# City of Alexandria, Virginia

## MEMORANDUM

**SUBJECT:** 213 SOUTH FAIRFAX STREET  
BAR2012-0262 and 263

Staff recommends that the Board approve the application, per amended plans dated September 12, 2012 with the conditions that:

A2.1

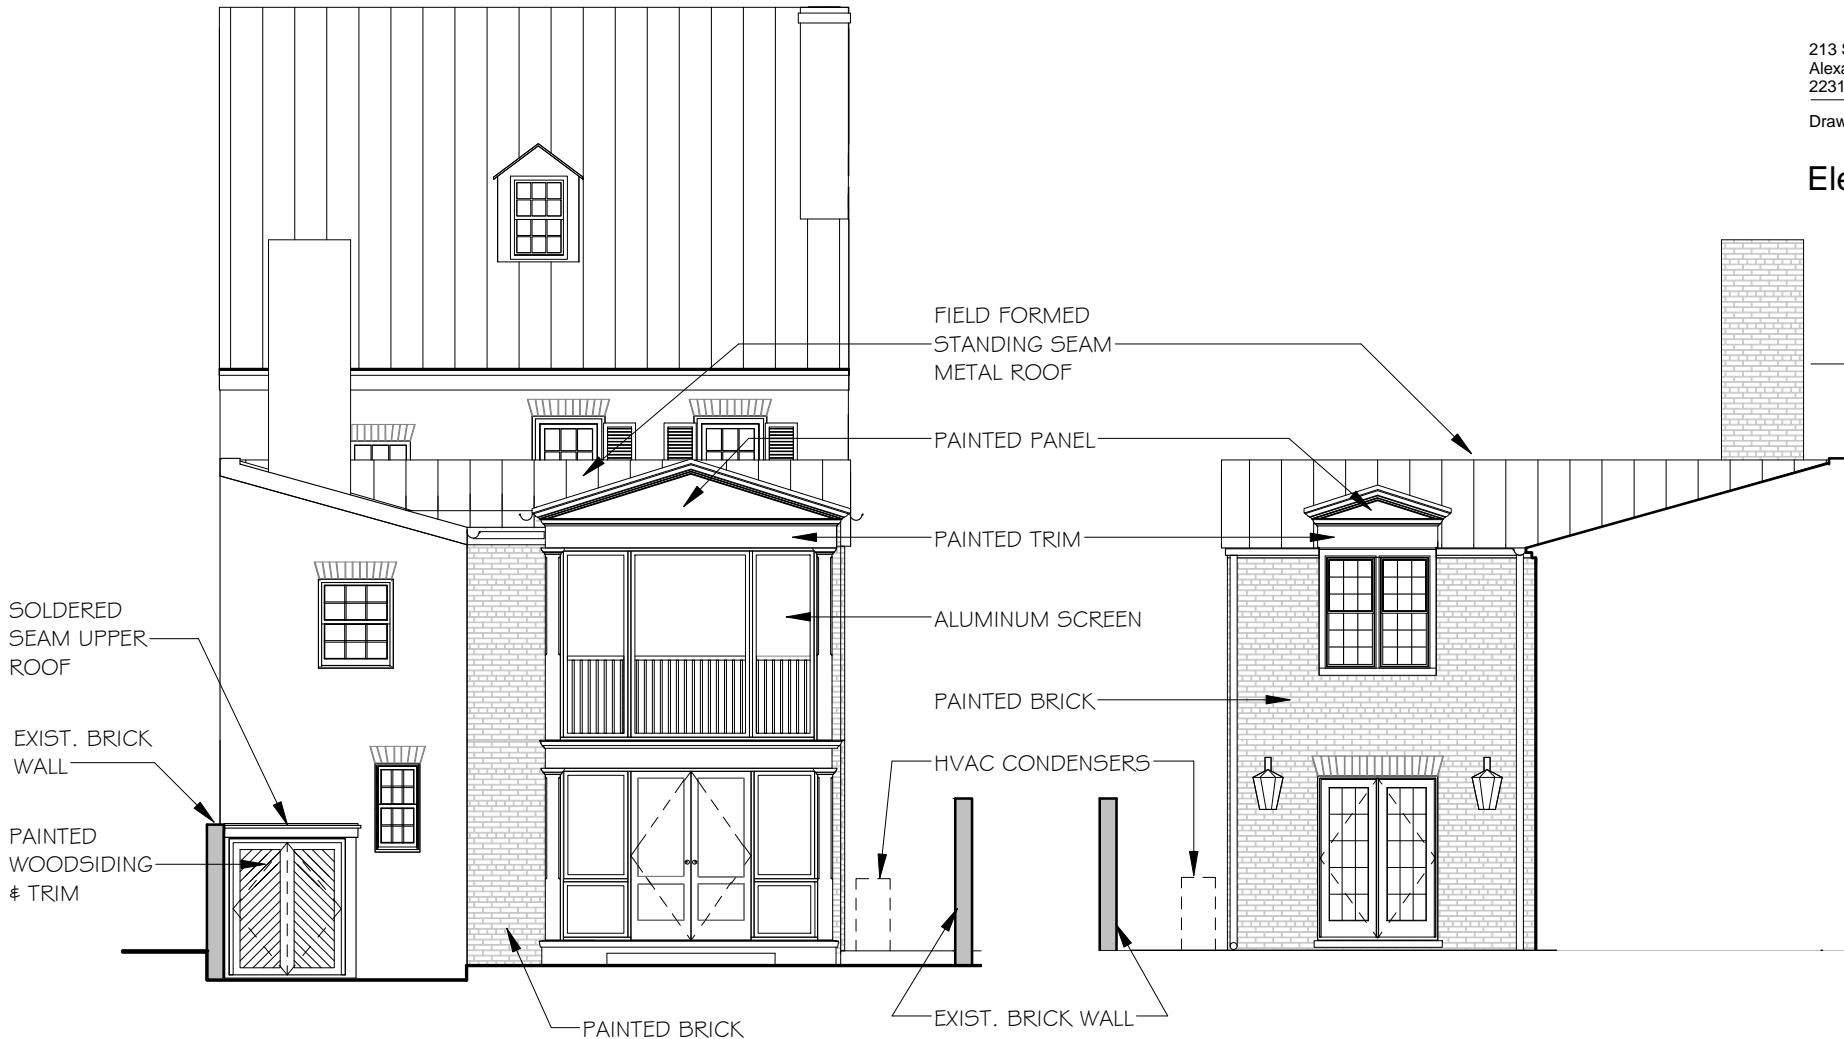
The applicant met with the neighbors and has responded to the Board's comments with a revised submission. The revised submission includes a slight re-design of the addition's roof, which lowers the east cornice of the addition and aligns it with the cornice on the rear ell. Additionally, the second floor east elevation windows have been converted into a gabled dormer with a set of paired, nine-over-nine windows. An additional window was added to the second floor of the south elevation to relieve the visual mass of this wall. Finally, the applicant has also offered to purchase three new trees for the neighbor's property, to mitigate the removal of two existing trees on the subject property that served as green privacy screening.

The applicant has submitted a revised design which addresses the concerns raised by the Board and the neighbors. The cornice height of the addition, as viewed from Fairfax Street, has been reduced and the roof forms simplified. Trees have been offered which will replace the lost tree canopy and soften the view from the neighbors and the street. The applicant has also submitted a plan sketch of this block based on the building footprints from the 1907 Sanborn Insurance maps which have been overlayed on the City's current real estate maps. This sketch shows the very modest size of the proposed addition relative to the large 20<sup>th</sup> century additions that have been approved on the neighboring houses.

**Area to be capsulated with new addition**

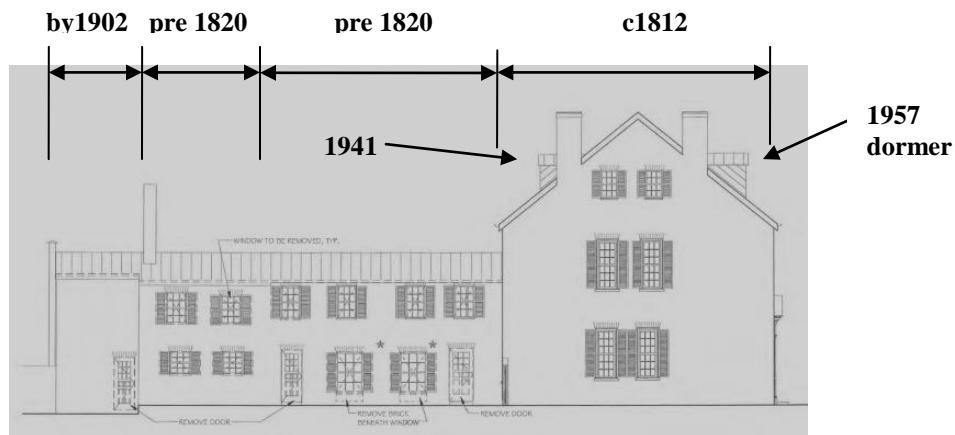
The proposed two-story addition will capsule the north wall of the later c1885 and 1902 additions and only one bay of the pre-1820s ell (see illustration below.)

The proposed capsulation is to be located on a secondary elevation, is barely visible from a public ROW and most of the current exterior walls will remain intact. The Board generally supports additions which follow these practices. Staff has examined the windows proposed to be replaced on the ell and has found the existing sashes are modern replacements, many with aluminum jamb liners and nailed butt joints. Additionally, the two windows on the first floor proposed to be demolished were shortened in a previous kitchen renovation. Also, it appears that only one or two of the windows and doors still retain the original early-19<sup>th</sup> century beaded trim. Based on these findings, Staff does not object to the proposed full-frame replacement of the windows on the addition with SDL, painted wood windows with a 5/8" muntin.
